Joel/Jennifer:

1. A marked-up version of HCD's recent SB-9 FactSheet with a couple of points noted. The key one in it that I would like to bring to your attention is: **HR. It Is Single Family**. You have to fix that one.

I understand that you are working on a revision to the SB-9 Ordinance to be debated on September 21st. On the whole - with the February revision to the Ordinance I think you got it pretty much right. I do, however, have a couple of questions/comments.

The 20 ft Fee Title Corridor for a Flag Lot.

THE 20' FEE TITLE CORRIDOR RULE.

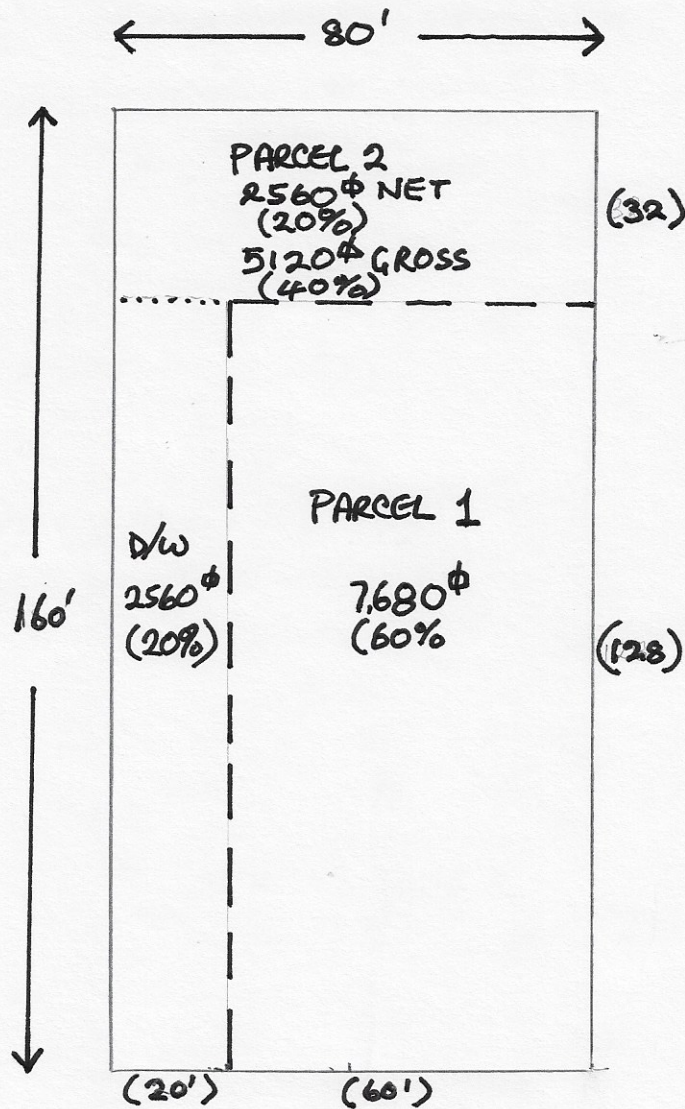
DOES THIS REALLY MAKE SENSE?

TOTAL LOT SIZE = 12,800 sq ft

60% LOT SIZE = 7,680 sq ft PARCEL 1

40% LOT SIZE = 5,120 sq ft PARCEL 2

BUT 1/2 IS CORRIDOR

20% ACCESS CORRIDOR - 2,560

20% NET LOT SIZE - 2,560.

IF YOU INSIST ON THE 20' WIDE "FEE TITLE"
THEN IT SHOULD BE DEDUCTED FROM THE
60/40% CALCULATION OR YOU COULD
HAVE STUPID LOTS.

BUT REALLY YOU SHOULD ALLOW/REQUIRE
AN EASEMENT TO THE BACK LOT TO SOLVE
THIS & MAKE THE EASEMENT WIDTH 12'-15'.

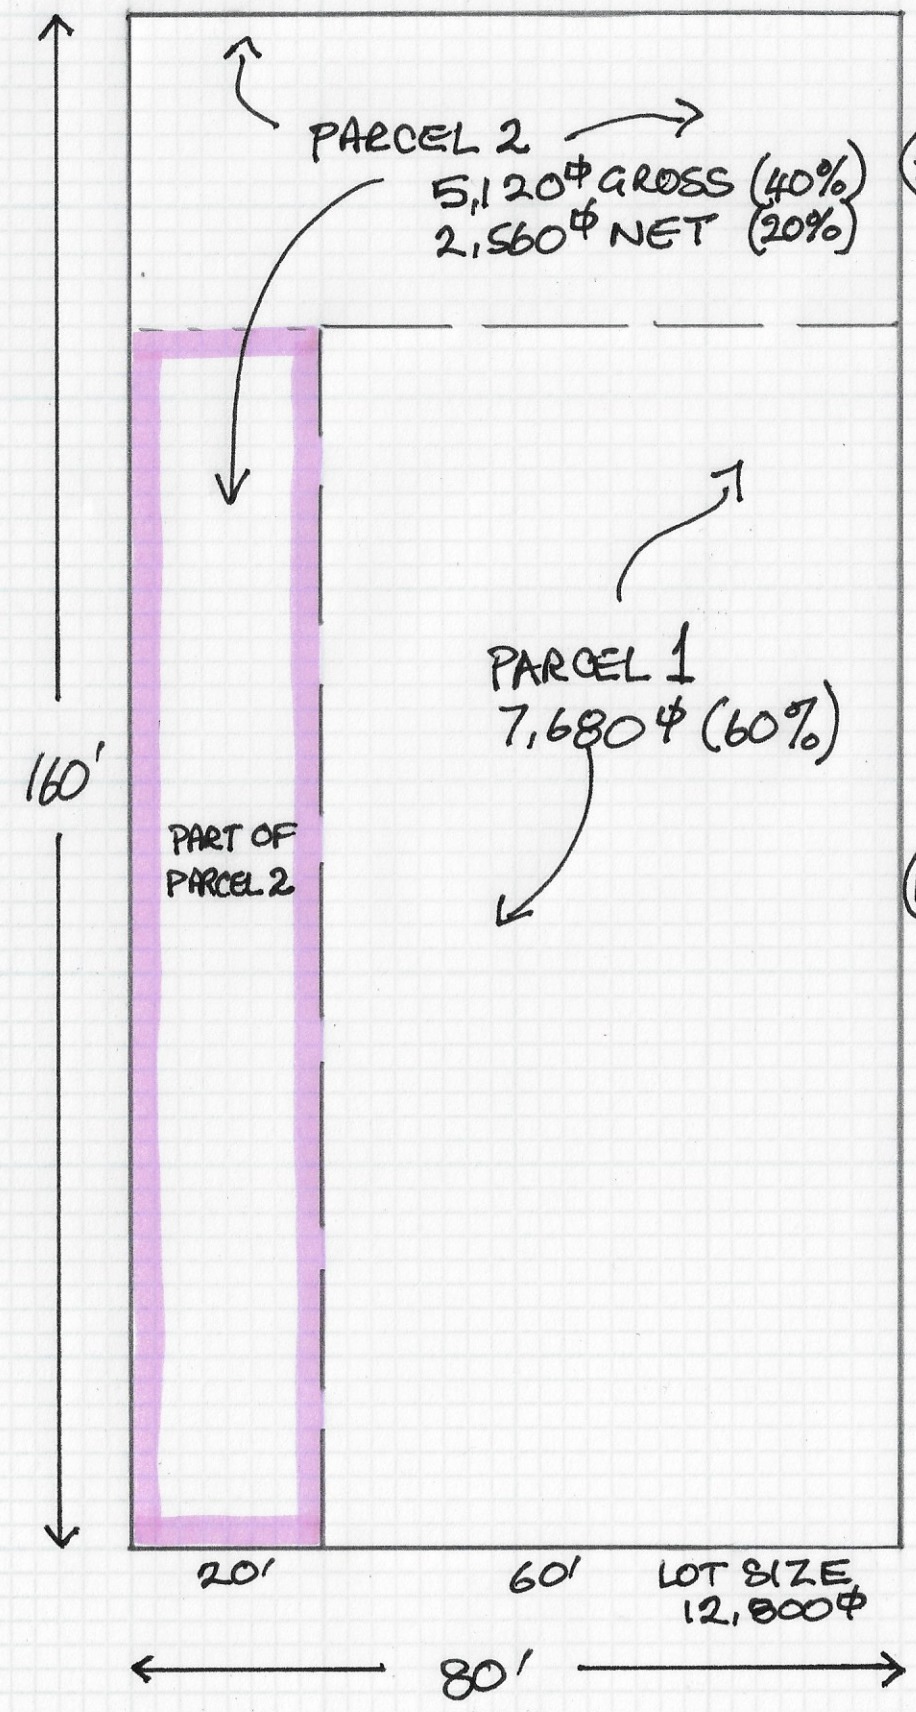
SB-9 does not really allow a jurisdiction to restrict a flag lot access corridor to being 'Fee Title', which the current ordinance does, so there will always be a risk of a legal challenge. All other local jurisdictions make provisions for an ingress/egress easement alternate access the rear parcel. Just because there is a "20 FT Street Frontage Rule" in the code now does not mean that is must stay for SB-9.

With the existing Ordinance you can get some really stupid lot configurations, not intended by SB-9 and not desirable in the Town. This is your chance to correct it. **THE EXAMPLE** shows what a homeowner could ask for "AS IS" and how you could "FIX IT" – 2 vastly different approaches to the same lot.

PROBLEM 2: THIS IS IN VIOLATION OF SB-9 WHICH SAYS A (FLAG) PARCEL MAY ADJOIN

OR HAVE ACCESS TO A PUBLIC RIGHT OF WAY
